Back inserts for XP-100 safety button

MOLD ASSEMBLY		RD CAV.	4	TYPE	INJECTION
		CUST.	REMINGTON	PROD.	SAFETY BUTTON
		PRESS	65 H100 MINIJECTOR		
SCALE	DATE	DR	LR	APP.	
	7-23-65	W/P			
J. G. TILP, INC.				JOB NO.	
UNION, N. J.				6982

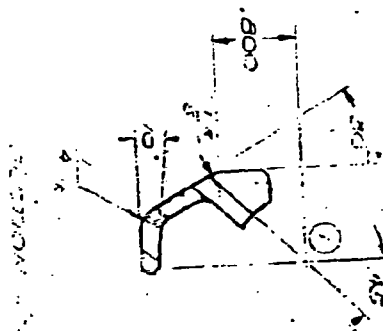
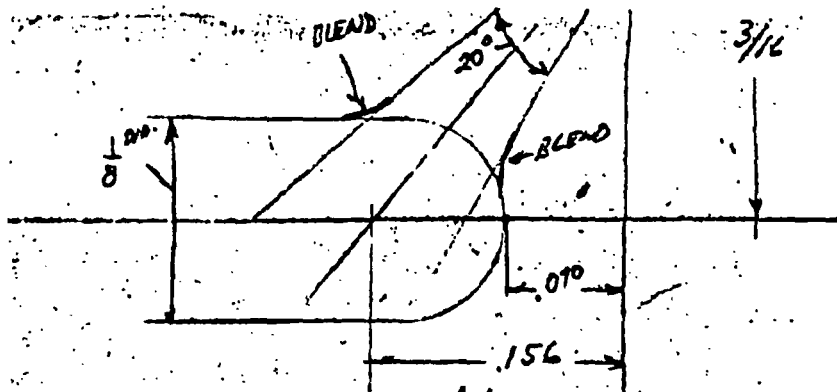
NOTE
CHECK GATE POSITION
ON PART. DNG. MUST BE ON
CORRECT SIDE.

NOTE (2) NEW CORES TO FIT INTERCHANGEABLE
WITH OLD CORES NEW SIZE ON WIDTH OF
LUGS ONLY WAS .055-860 NEW SIZE .080-075
JOB # 4460

NOTE
CHECK GATE POSITION
ON PART. DNG. MUST BE ON
CORRECT SIDE.

NOTE (2) NEW CORES TO FIT INTERCHANGEABLE
WITH OLD CORES NEW SIZE ON WIDTH OF
CORES ONLY WAS .035-.060 NEW SIZE .000-.025
JOB # 4460
